3 Detailed description of change

Product Change Notification					Isolation material change OGN-SMD		
owner	creation date	release date	released by	change order no	rev	page	D10-014-013
dislercy	2017-02-22	2017-02-22	nowakfr	2011797	A	1 of 2

Old product marking		New product marking

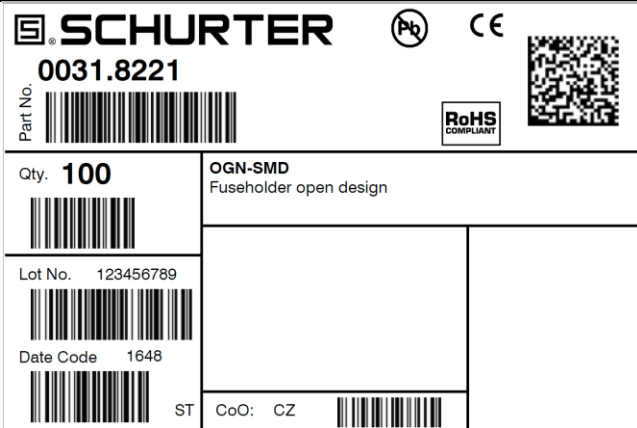
- Change of material
- Modified label
- Improved electrical ratings
- Change of markings

Form	Yes	Inscription on socket and isolation material changed
Fit	No	No change for dimension
Function	Yes	Moisture sensitivity level 1 acc. JEDEC J-STD020E Rating enhancement acc. to IEC and UL
Manufacturing	No	No change for manufacturing site
Label	Yes	Approvals and configuration code on label
Packaging	No	No change in packaging

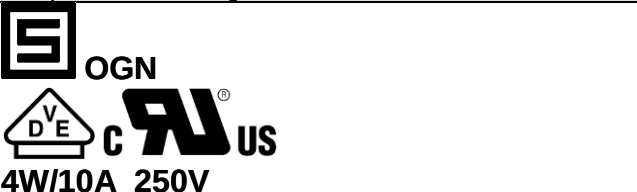
Old product approval		New product approval	
UL 4248-1 - CSA C22.2 no. 4248.1 10A, 500V AC or DC IEC 60127-6 (VDE) 4W, 10A, 250V AC		UL 4248-1 - CSA C22.2 no. 4248.1 16A, 500V AC or DC IEC 60127-6:2014 (VDE) 4W, 16A, 500V AC 4W, 10A, 500V AC (with cover) 2.5W, 10A, 500V AC (with transparent cover)	
Old label		New label
